**La Jolla Shores Planned District Advisory Board (LJSPDAB)
APPLICANT PROJECT INFORMATION FORM**

HERMANNY HOUSE

Site Development Plans PRJ-1099348.pdf

LA JOLLA (Process 3) Site Development Permit and Coastal Development Permit for construction of a new two-story single-family residence (7,509 sq. ft.) with a basement/garage (3,034 sq. ft.) at a vacant site (346-831-4400 0 Ruelle Nicole). The 0.4-acre site is in the LJSPD-SF, Coastal (Non-appealable) overlay zone within the La Jolla Community Plan area. Council District (1).

PROJECT NUMBER: HERMANNY	SHEET: A3.00
DRAWING DATE: 03/24/23	SHEET X OF X
SCALE: 3/16" = 1'-0"

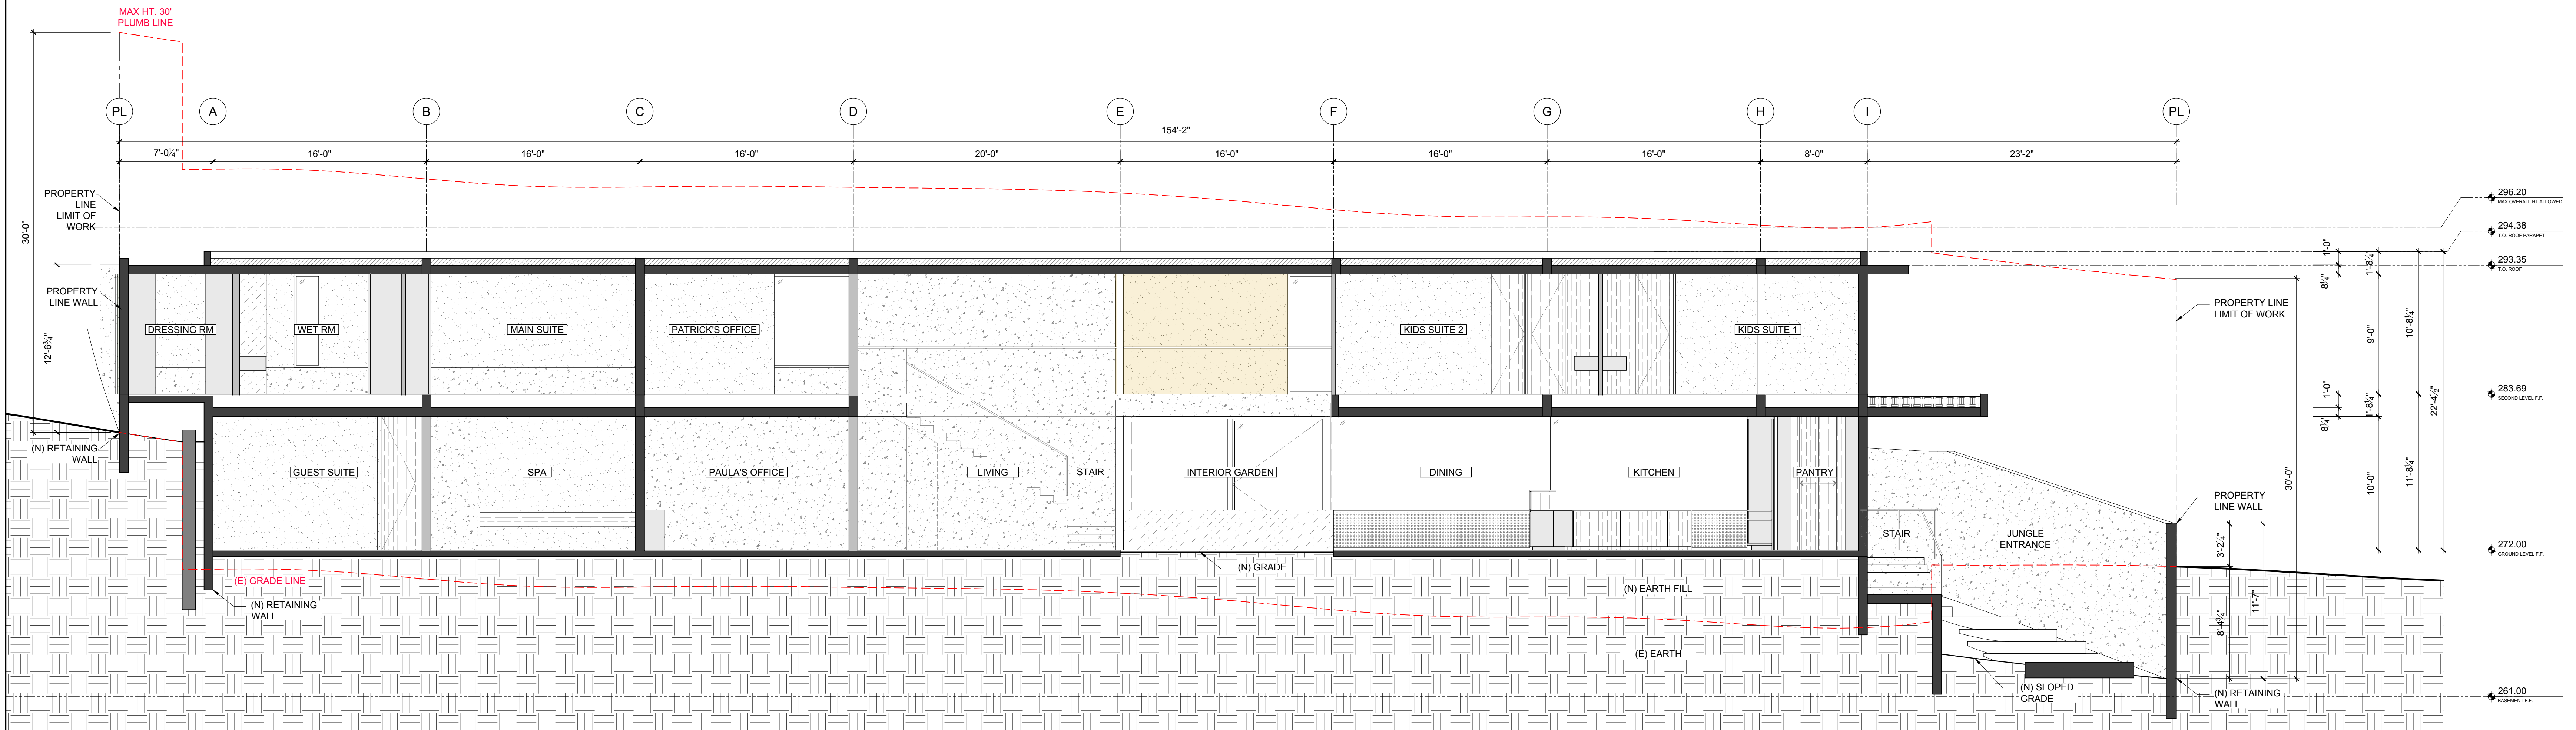
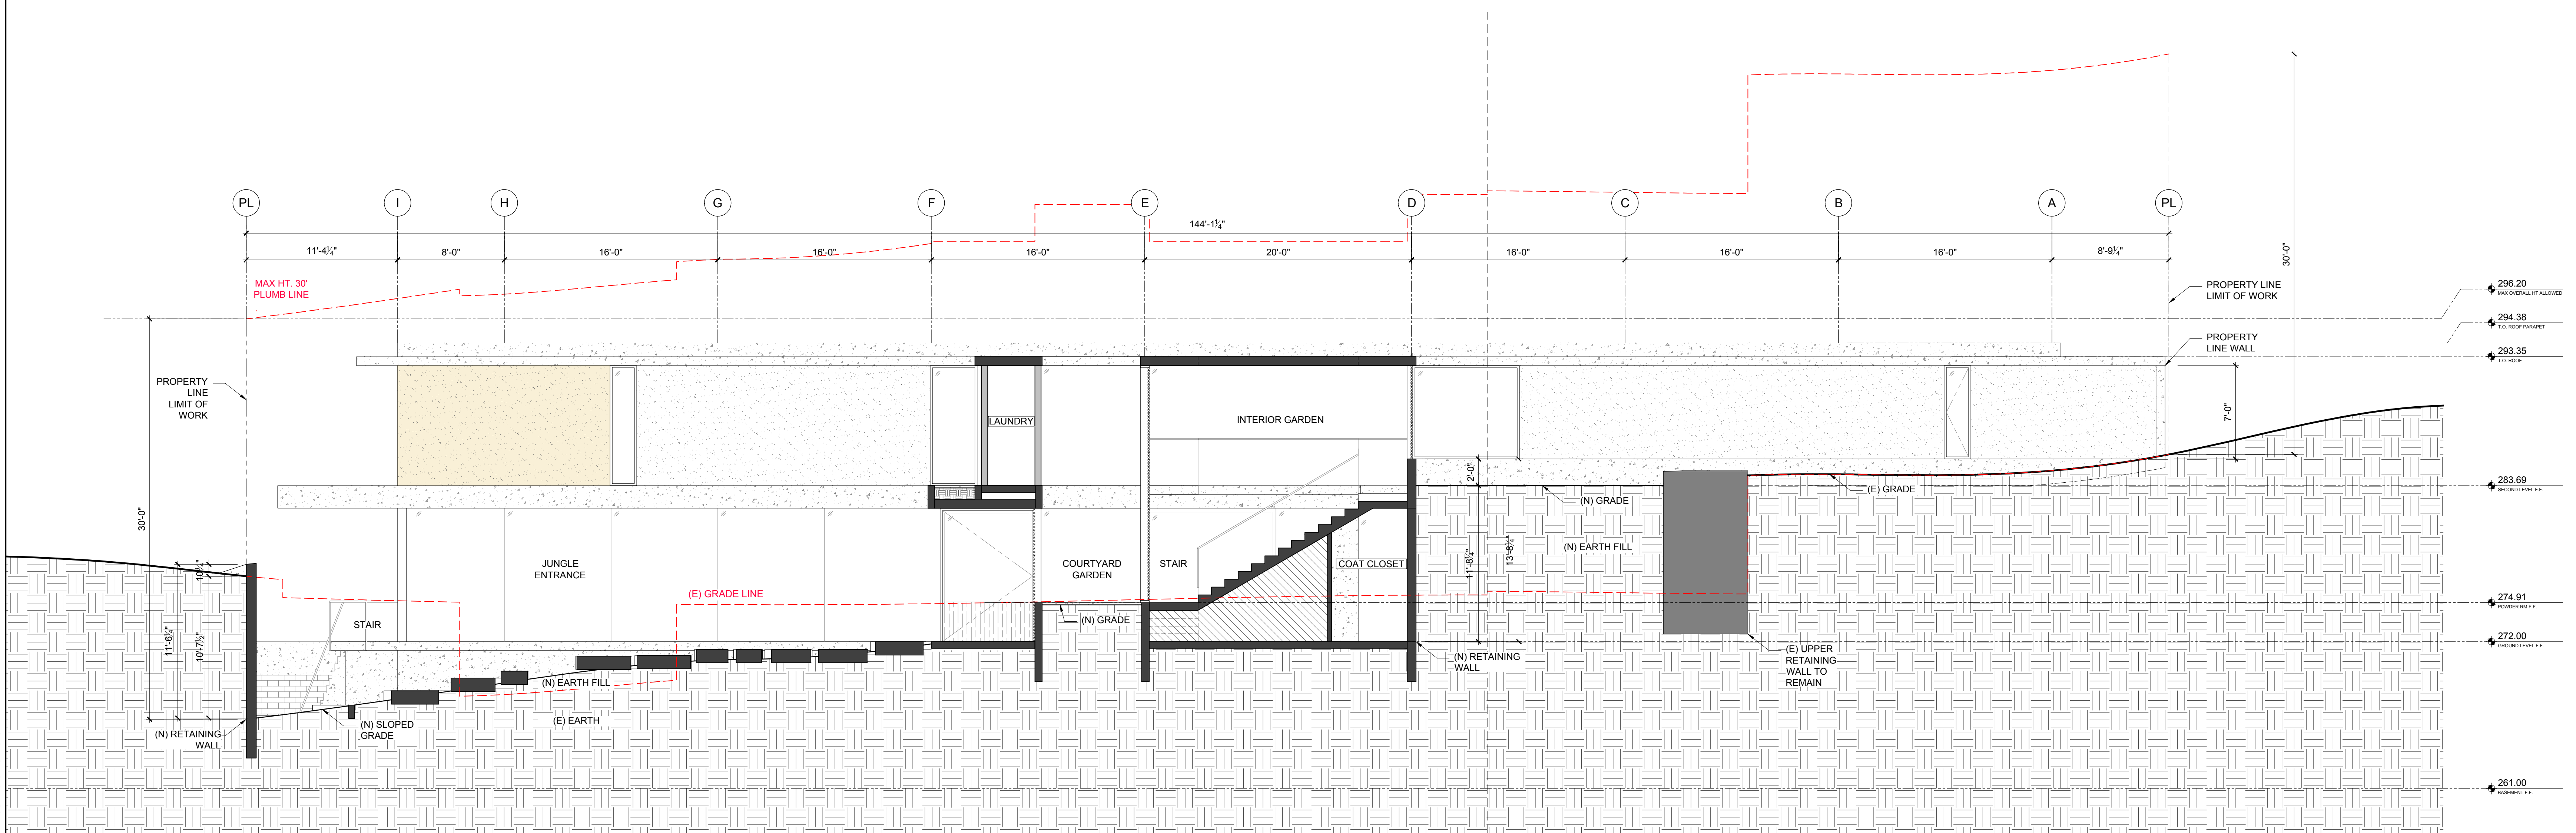
The project is located within the Coastal Height Limitation “Prop D” Overlay Zone, Plumb Line, and Overall Height (Base Zone 30’) and shall conform to all three height requirements. The project appears to comply with all three height requirements. However, the project shall illustrate Coastal Height Limitation 5-4, where the measurement is based on the exterior wall of the building and not the farthest projection. Please refer to Technical Bulletin 5-4 regarding these measurements and present the 5’ measurement of the wall of the structure with its perimeter, as shown in Figure 1.

In addition, the applicant must demonstrate the grade differential measurement from the highest or lowest point of the structure. If the grade difference is less than 10’, the measurement shall be taken from the highest-grade datum. Please refer to the illustration Figure 2. If the grade differential is 10’ or more, the measurement shall be taken from the lowest grade datum. Please refer to the illustration Figure 3
